SERVICE BULLETIN

REFERENCE ENGINE _____
 NUMBER 029
 DATE 11-25-88
 MODEL VN

GURGLING (WATER RUSHING) NOISE FROM HEATER CORE

SYSTEM LAYOUT:

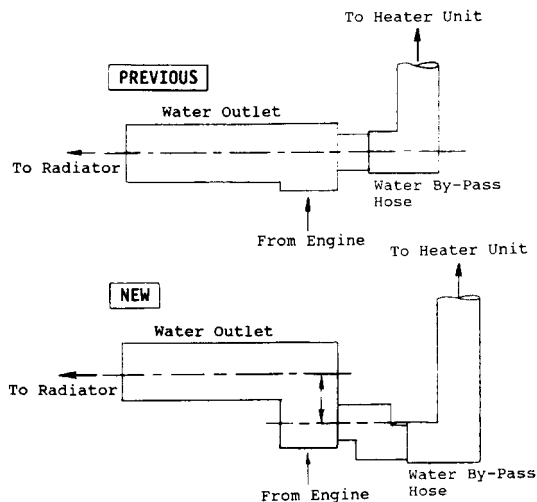
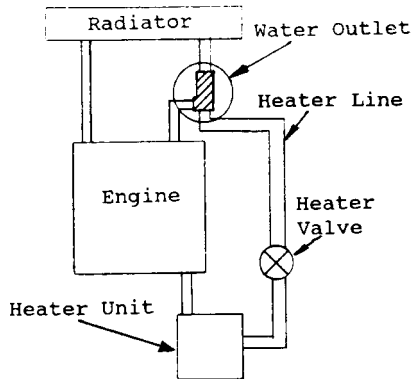
To prevent the gurgling (water rushing) noise from the heater core due to air being trapped in the system, the following production change has been adopted. (See following illustrations).

PART NAME	Prev. P/N	New P/N
Hose, Water By-Pass, No. 1	16261-65010	16261-65011
Outlet, Water	16331-65010	16331-65011

For field fix 4x4 V-6 vehicles produced before the production change, install both by-pass hose and water outlet as a set.
